RE: Mesa Cold Storage Grading and Drainage Plan Engineer's Stamp Date 4-6-2017 (File: H13D108)

Based upon the information provided in your submittal received 4-6-2017, the above referenced Grading and Drainage Plan is approved for paving permit and SO-19 permit with the following condition:

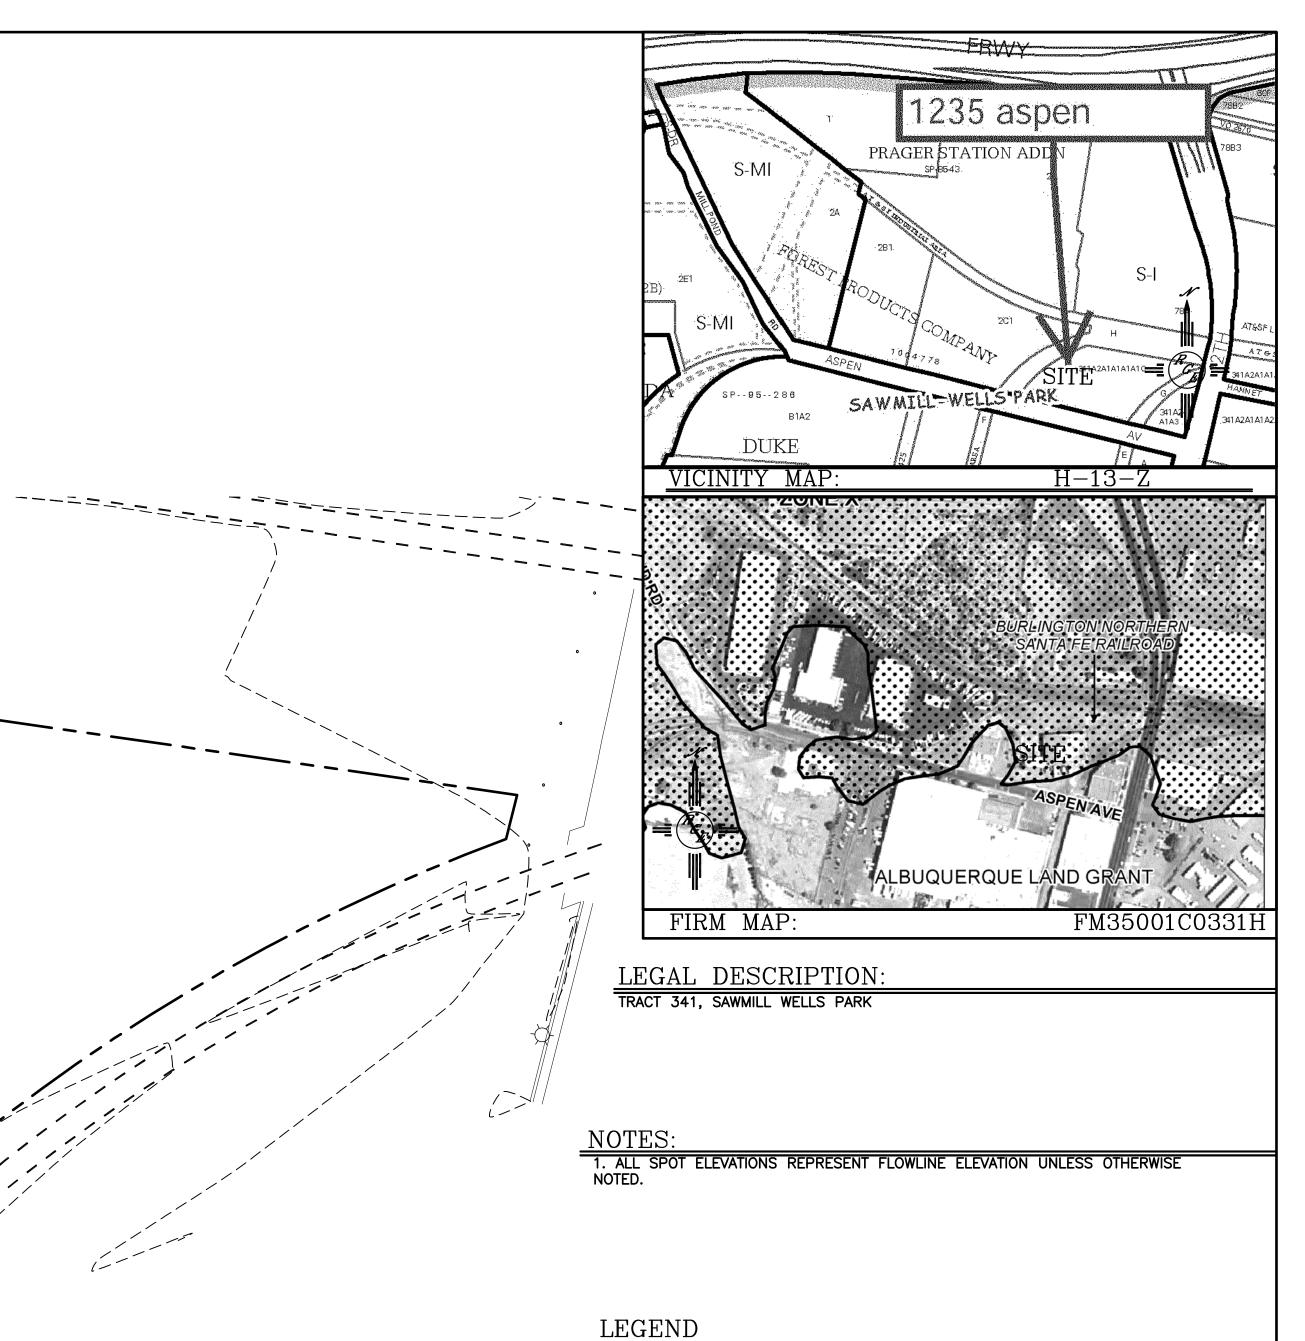
• Change the grade from 4961.14 to +/- 4962.36.
